UNITED STATES PATENT AND TRADEMARK OFFICE

APPLICATION NO.	FILING DATE	FIRST NAMED INVENTOR	ATTORNEY DOCKET NO.	CONFIRMATION NO.
10/624,219	07/22/2003	Scott A. Melton	2206.68153	6953
24978	7590	03/10/2005		
GREER, BURNS & CRAIN 300 S WACKER DR 25TH FLOOR CHICAGO, IL 60606			EXAMINER TSUKERMAN, LARISA Z	
			ART UNIT 2833	PAPER NUMBER

Office Action Summary	Application No.	Applicant(s)	
	10/624,219	MELTON ET AL.	
	Examiner	Art Unit	
	Larisa Z. Tsukerman	2833

DETAILED ACTION

Attachment 1

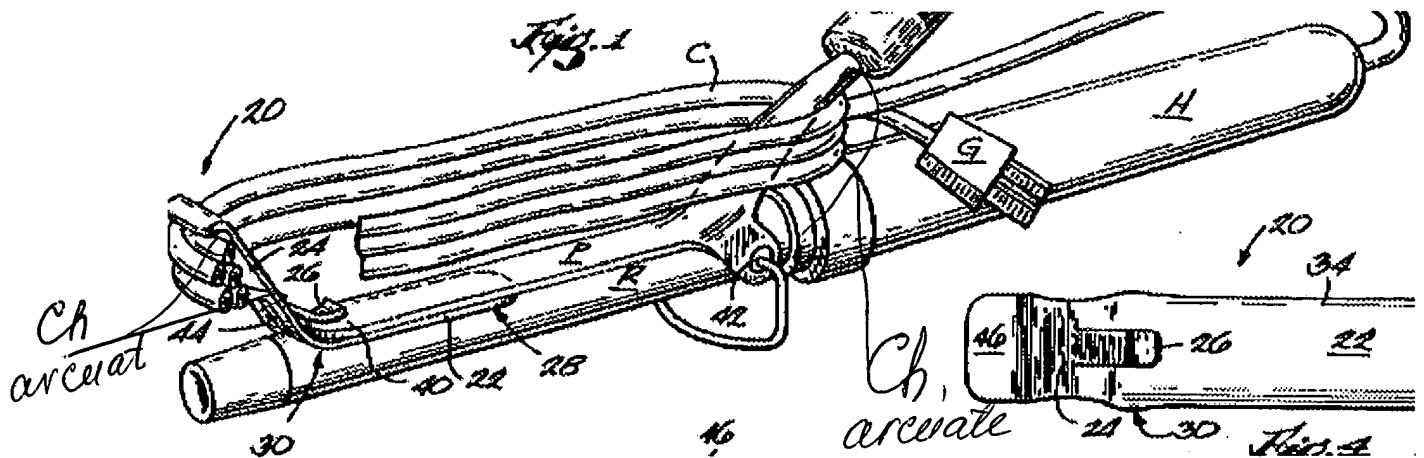
In regard to claim 1, St. Peter discloses a cord wrap 20 for use with a clipper (curling iron) configured for accommodating a power cord C, the cord wrap 20 comprising:

at least one retaining structure 22, 24, 26 configured for retaining the power cord C on the clipper (curling iron); and

a cord channel Ch (see Attachment 1) disposed on the at least one retaining structure 22, 24, 26 and configured for supporting at least one loop (not marked, see Fig.1) of the cord C.
